**MEETING**

**PLANNING COMMITTEE**

**WEDNESDAY 26TH APRIL, 2017**

**Condition 98**

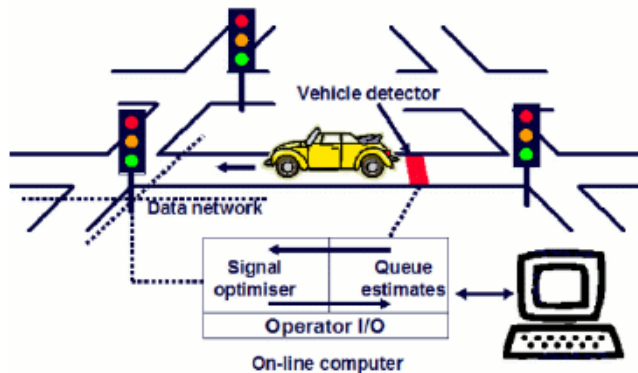
*LBB Comment - The response to Condition 98 states: 'As there appears to be no overall increase in traffic it is not considered that any such changes are necessary to accommodate the additional traffic of the first units of Phase 4 in advance of the requirement for the major highway works.'*

*How many of the 1058 residential units permitted to be occupied prior to completion of the major highway works were actually being lived in at the time of the survey on the 6th June 2016?*

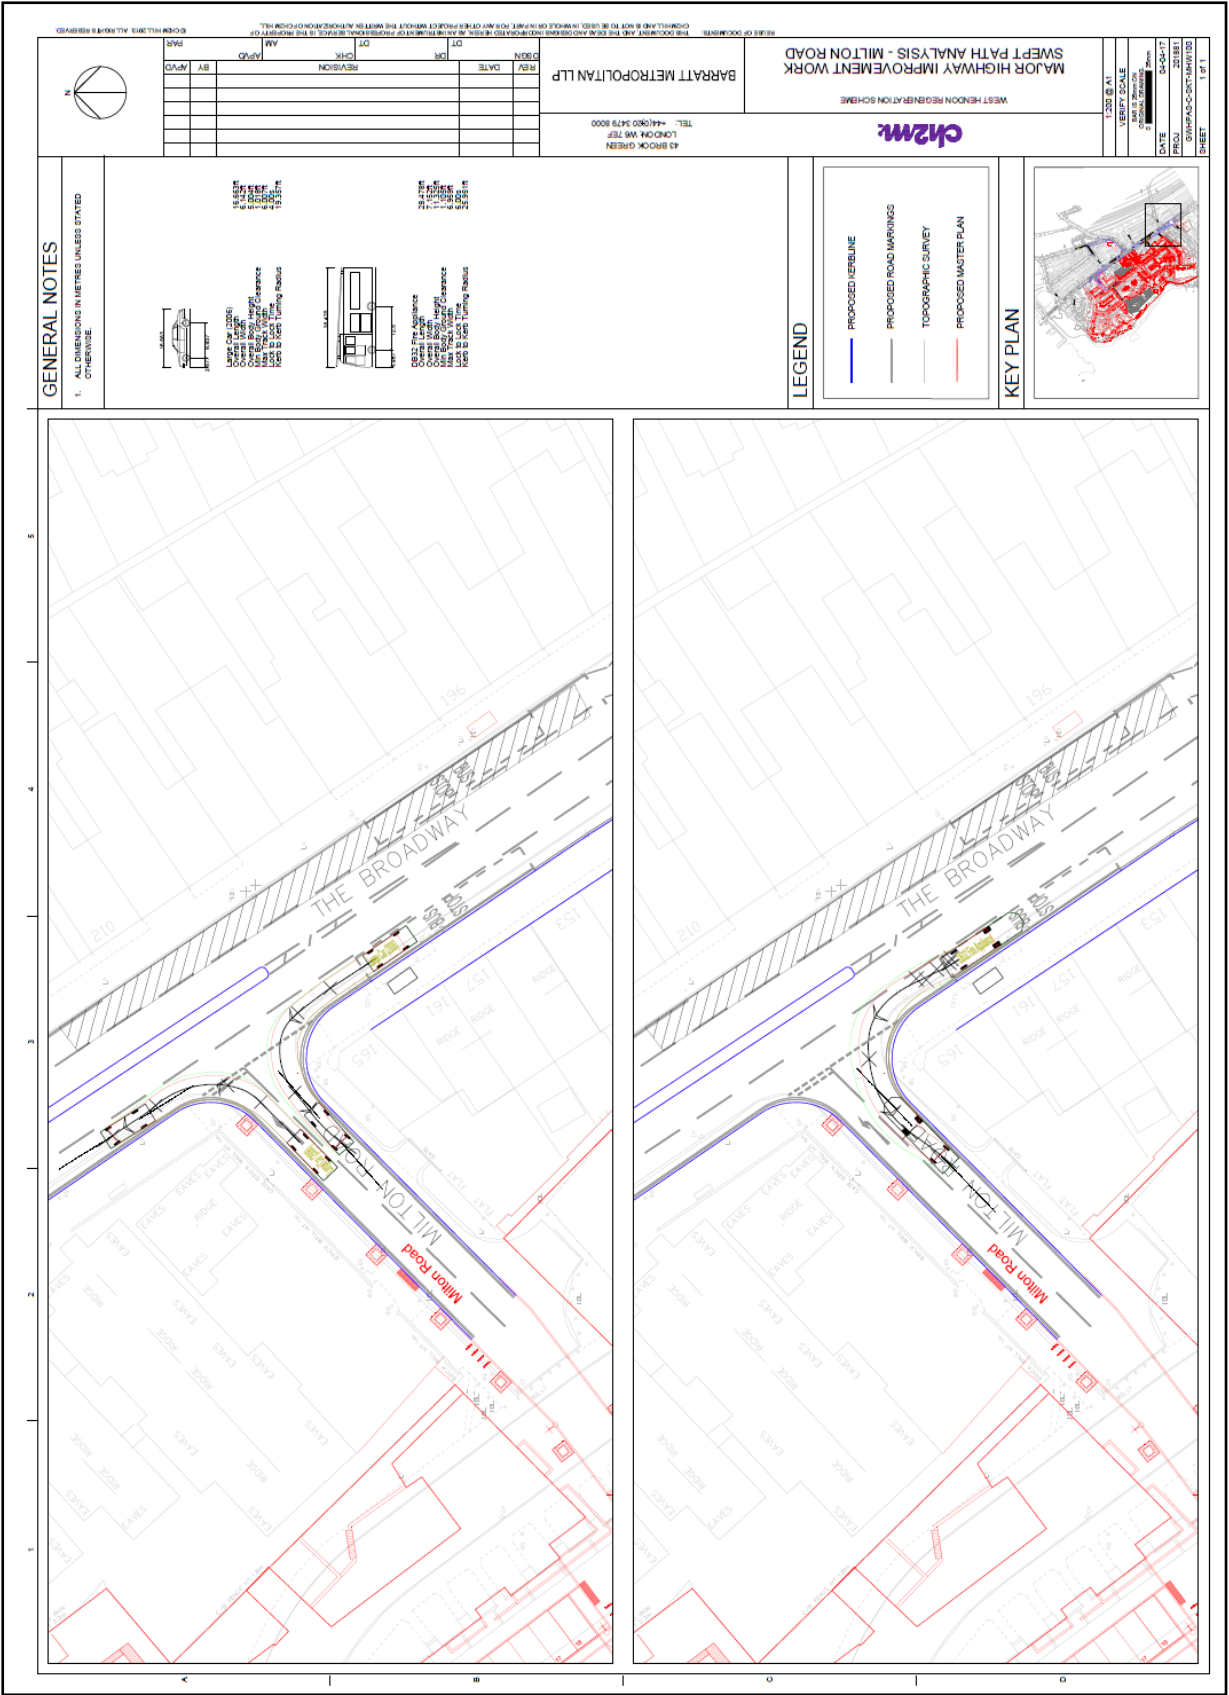
**LBB Comment** - The following reviews have been undertaken of the proposed design drawings DWGWHPAS-C-DWG- 4400 and DWGWHPAS-C-DWG-4405 to 4410:

CH2M can also confirm that the loading bay located on Station Road is not being removed and will stay in its current location. With regard to pedestrian and vehicle conflict areas on Stanley Road, the Shared Surface has been created in order to create a 'homezone' feel and act as a form of traffic calming, principally by means of geometry but with sympathetically detailed traffic calming measures where required.

CH2M can confirm that no refuse vehicles will reverse onto a ramp for collection. This drawing error and confirm that all refuse will be collected at street level. Currently no agreement has been made for the collection of bins from the A5. However, it is envisaged that collection along the A5 would continue in its current form.
